# Access Compliance Report

## Public Rights-of-Way

### (Curb Ramps)

Intersection ID: N/A	Main Street: SOLAR_WY	Cross Street: ROCK_ISLAND_RD	Location: SE
ADA ID: EE08F5766EA0	Ramp Type: Perp	Initial Pass/Fail: Fail	Overall Compliance: No
Severity Score: 12.5			
Codes/Mitigation Info/Possible Solution		Field Measurements/Component Compliance

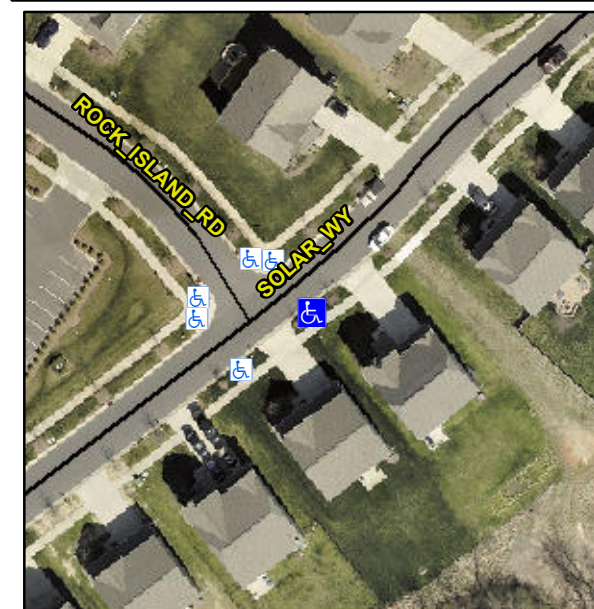
**Remove & Replace Entire Ramp.**

**R304.5.3**

Compliance	Description	Data	Compliance	Description	Data
N/A	Ramp Length (in)	95.0	Yes	Ramp Slope (%)	5.2
Yes	Ramp Width (in)	48.0	No	Ramp XSlope (%)	5.5
N/A	Flare Type LT	N/A	N/A	Flare Type RT	N/A
N/A	Flare Slope LT (%)	N/A	N/A	Flare Slope RT (%)	N/A
N/A	Flare Traversable LT?	N/A	N/A	Flare Traversable RT?	N/A
N/A	Landing Length (in)	N/A	N/A	DWS Provided?	N/A
N/A	Landing Width (in)	N/A	N/A	DWS Contrast?	N/A
N/A	Landing Slope (%)	N/A	N/A	DWS Length (in)	N/A
N/A	Landing X Slope (%)	N/A	N/A	DWS Full Width?	N/A
N/A	Landing Curb? (Y/N)	N/A	N/A	DWS Offset (in)	N/A
N/A	Shared Landing?	N/A			
N/A	Gutter Ponding?	N/A	N/A	Gutter Slope (%)	N/A
N/A	Gutter Lip Ht (in)	N/A	N/A	Gutter X Slope (%)	N/A
N/A	Painted X Walk1?	No	N/A	Painted X Walk2?	N/A
	X Walk 1 Direction	To NW		X Walk 2 Direction	N/A
N/A	X Walk 1 Width (in)	N/A	N/A	X Walk 2 Width (in)	N/A
	X Walk 1 Slope (%)	2.2		X Walk 2 Slope (%)	N/A
	X Walk 1 X Slope (%)	4.4		X Walk 2 X Slope (%)	N/A
